Updated Non Technical Summary Addendum

Ashton Keynes Anaerobic Digestion Facility, Wiltshire

Acorn Bioenergy Limited

17 October 2025

Figure 2.3 Original Design (Red Dotted Line) and October 2024 Design

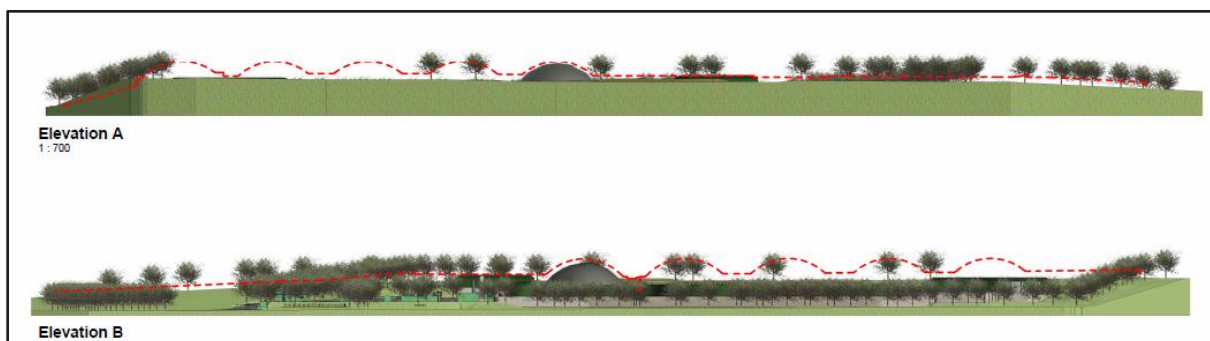
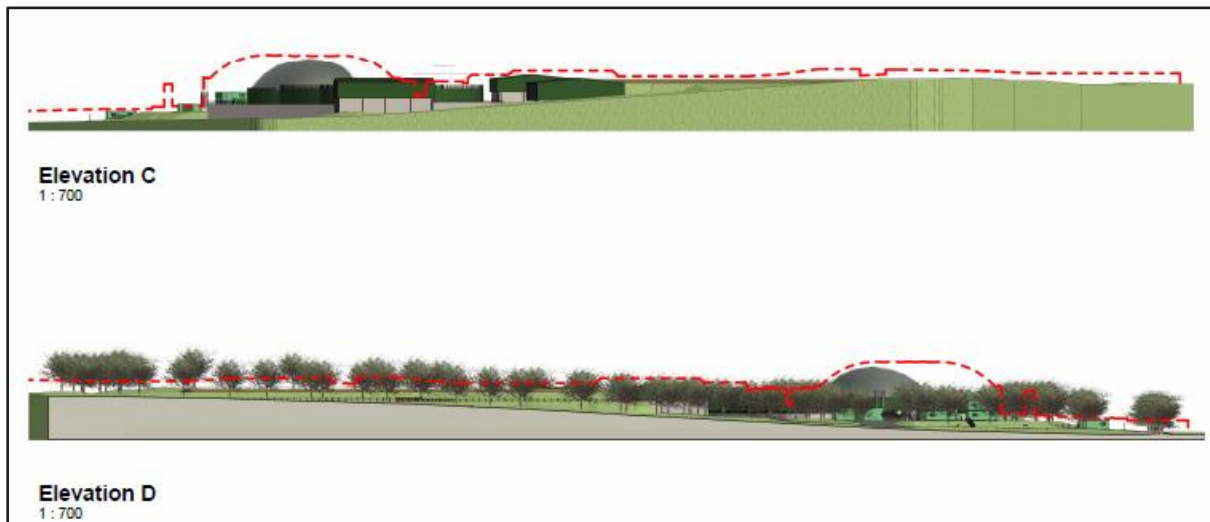
- The massing of the digester tanks along the Site's eastern boundary was reduced by proposing just three tanks instead of the original five tanks;
- The scale of the digester tanks was also significantly reduced. Originally the five tanks were all domed and rose to a height of 17m. The revised scheme proposes two flat tanks at just 9m tall and only one domed digester tank at 17m;

The full extent of the reduction in scale, bulk and massing delivered by the October 2024 Design changes is shown on submitted drawing 29419 F115 Rev B Elevation Views – Previous and New Planning Scheme (extracted at Figures 2.3 and 2.4 below):
